Village of Bellevue
Plan Commission Meeting
TUESDAY, JUNE 15, 2021
Village Hall/Public Safety Building
3100 Eaton Road
6:00 PM

PLAN COMMISSION MEETING OF 6/15/2021 AGENDA ITEM PLAT 2021-0001

PLAN COMMISSION MEETING OF 6/15/2021 AGENDA ITEM PLAT 2021-0003

CRYSTAL COVE

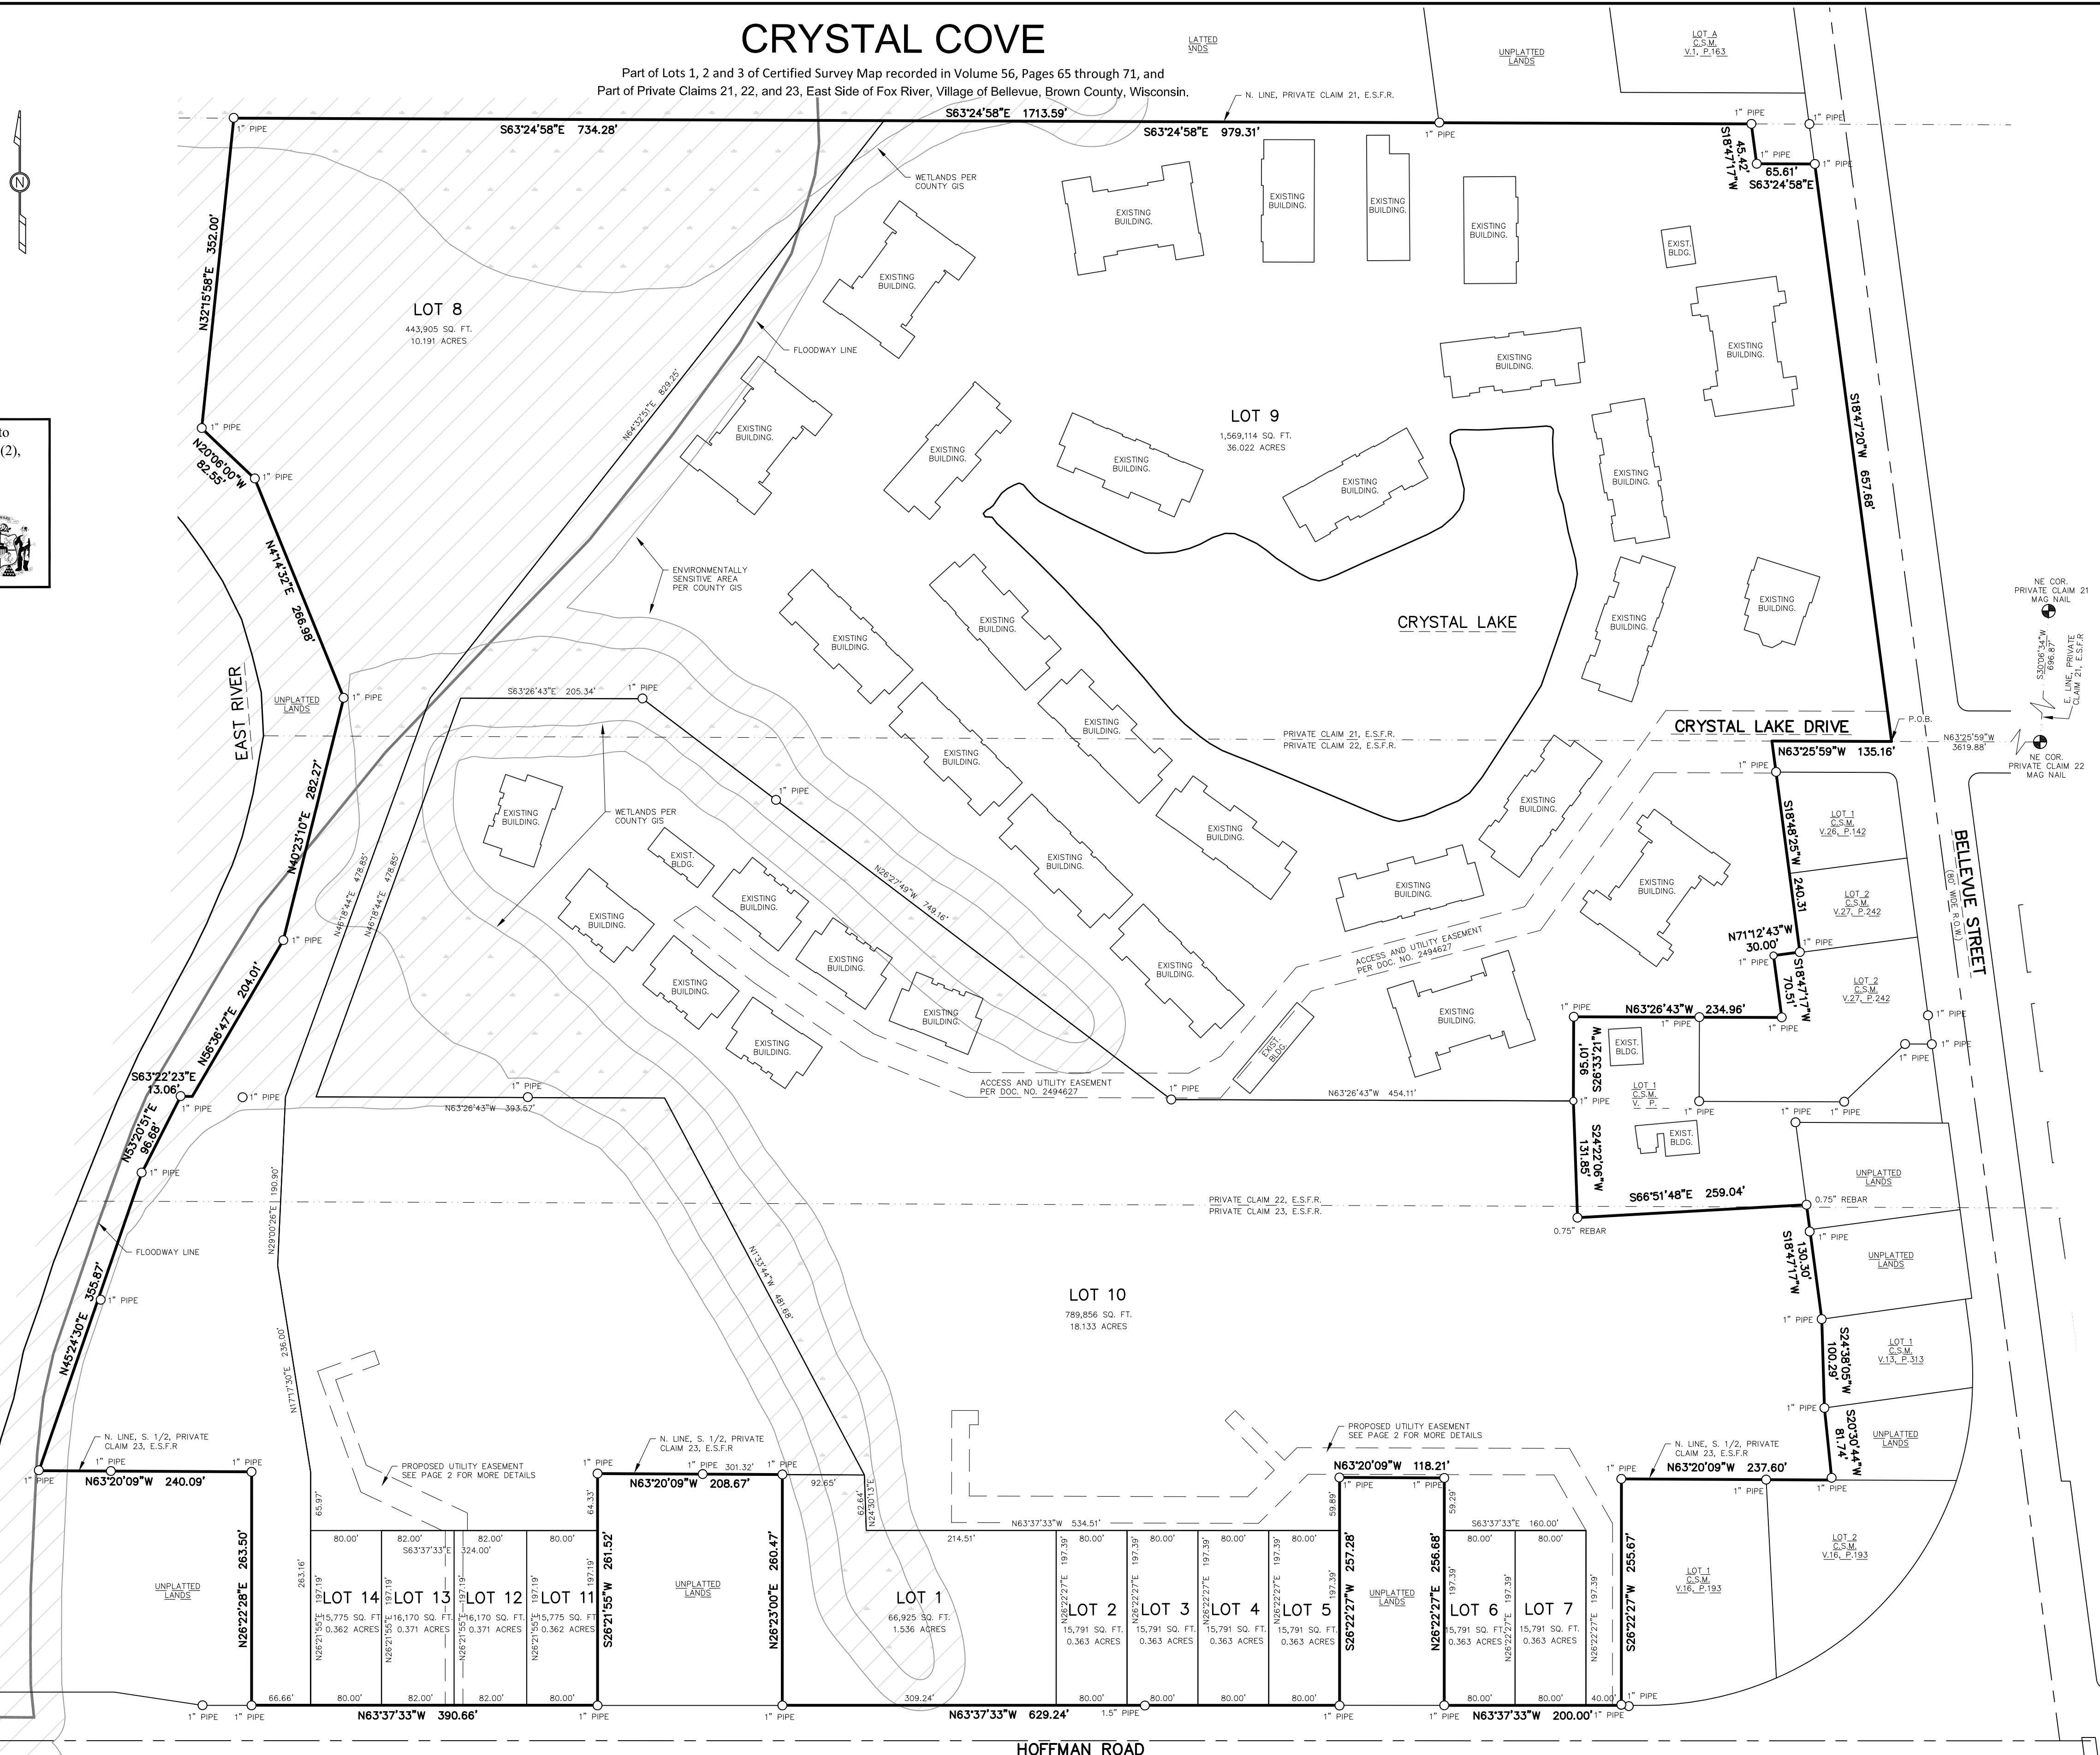
1. Review, approval, and signature from Brown County Planning Commission.
2. All easements as required by reviewing agencies.
3. Identify a 12' utility easement along all the road frontages for all Lots.

4. Identify the required front yard setbacks for proposed Lots from adjacent streets.
5. Provide grading and drainage plan subject to review and approval by Director of Public Works.

6. Change the title block from "Village of Bellevue Resolution" to "Certificate of Village of Bellevue".
7. Add all the standard Notes and Restrictive Covenants to the Plat.

8. All new driveways will require approval from the Brown County Highway Department when connecting to a Brown County Highway facility. A note shall be added to the proposed Plat to that condition.

9. A copy of the recorded document shall be provided to the Village of Bellevue electronically by the applicant.
10. Utility easements identified on Lots 9 and 10 and running between Lots 12 and 13 are for private utilities and not intended for public use. A note should be added to the Plat indicating as such.

There are a number of standard items that typically appear on plats that we are recommended to be added as this item advances. Numerous existing easements and well as notes and covenants are not shown. Those will need to be identified on the plat.

DRAINAGE: The applicant/owner will be responsible for working with the Village of Bellevue on all drainage associated with the subject property, and for compliance with the Village of Bellevue Storm Water Ordinance. Staff questions how the future home sites along Hoffman will drain and if easements are needed for drainage and stormwater management.
